## Northville DDA Economic Development Committee

**Preliminary and Final  
Site Plan Review  
For  
City of Northville, Michigan**

<b>Applicant:</b>	157 E. Main, LLC Rob Baidas 25000 Assembly Park Dr. Wixom, MI 48393
<b>Project Name:</b>	Rooftop Dining & Stairwell Addition
<b>Plan Date:</b>	November 17, 2020 (With revised sheets A-220, A-301, CS-001 and SS-301 dated December 14, 2020)
<b>Location:</b>	157 E. Main St. (North side of E. Main St., just west of Hutton St.)
<b>Zoning:</b>	CBD – Central Business District
<b>Action Requested:</b>	Preliminary and Final Site Plan Approval
<b>Required Information:</b>	As noted within this review

### **157 E. Main / Preliminary and Final Site Plan Review (Rooftop Dining & Stairwell Addition)**

SHEET CONTENT:  
**PROPOSED EXTERIOR ELEVATIONS**

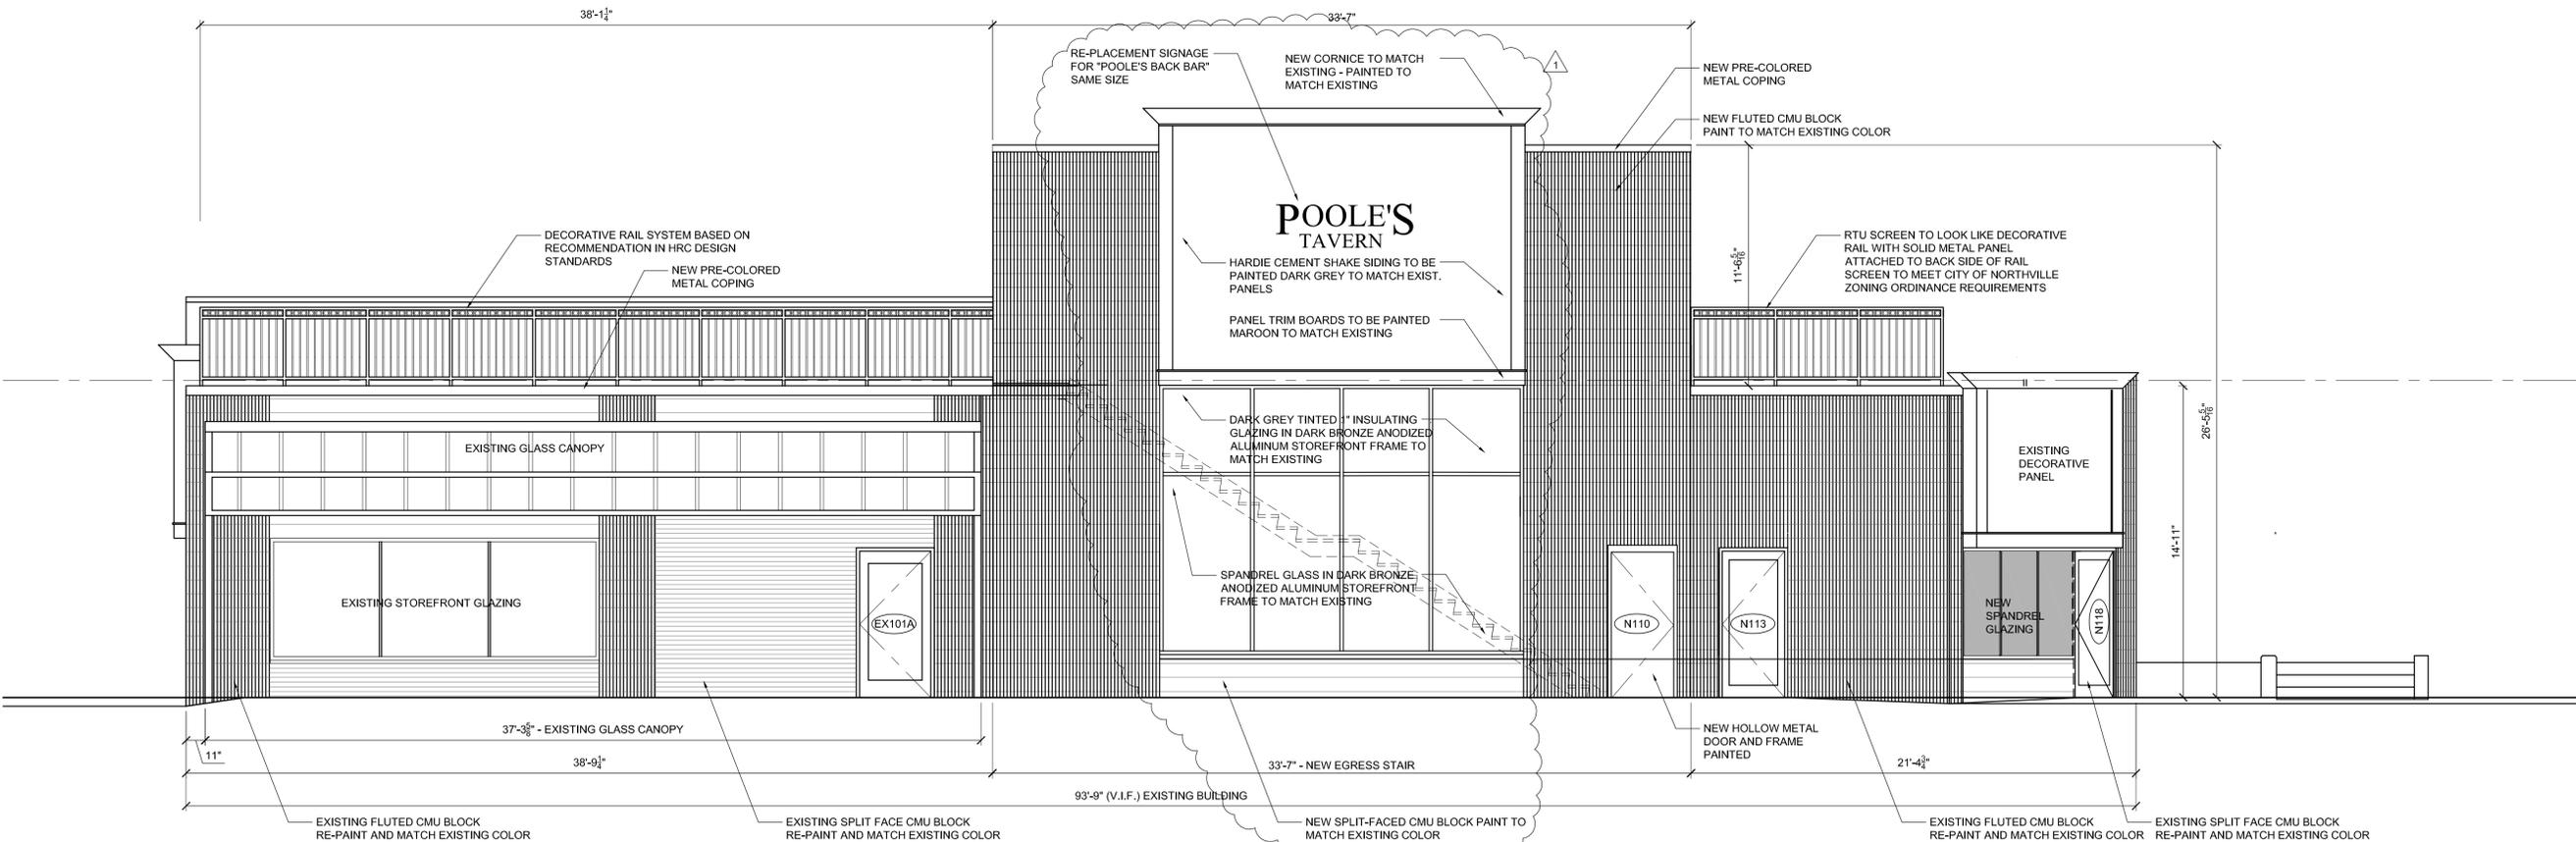
A new sign is shown on the eastern façade on revised Sheet A-301. The new sign will replace an existing sign of the same size. The HDC will also need to review and approve the sign. Also, the Building Official will review the proposed sign for the Sign Permit.

The revised elevations (Sheet A-301) show that the proposed stairwell addition will be constructed with CMU fluted block that matches the existing facades of the building. Tinted glass windows are being proposed on the stairwell façade to help break up the large expanse of blank wall. The upper story of the stairwell will contain siding, with a new cornice, to match the existing design on the front of the building. The rooftop seating will be surrounded with decorative railing that is consistent with the DDA's design standards. A screen to look like the decorating railing is located on the rear roof area to screen the mechanical equipment.

The EDC recommended that some type of rooftop cover over the dining area be added. The applicant should respond to this idea. If a roof-type structure is desirable, this information needs to be incorporated into the site plan submittal.

Lastly, the Building Official and Fire Chief both commented on the occupant load of the rooftop area; stating that two separate stairways would be necessary. These comments were provided before the revised sheets (dated December 14, 2020) were submitted. The revised sheets include a detailed analysis of how maximum occupancy was determined. We asked the Building Official to evaluate the revised sheets, and occupancy load. He stated to us via e-mail that he agrees with the analysis, and the rooftop dining area is not required to have two separate egress stairwells. The applicant should respond to this update, and whether they plan to keep both stairways, or eliminate one.
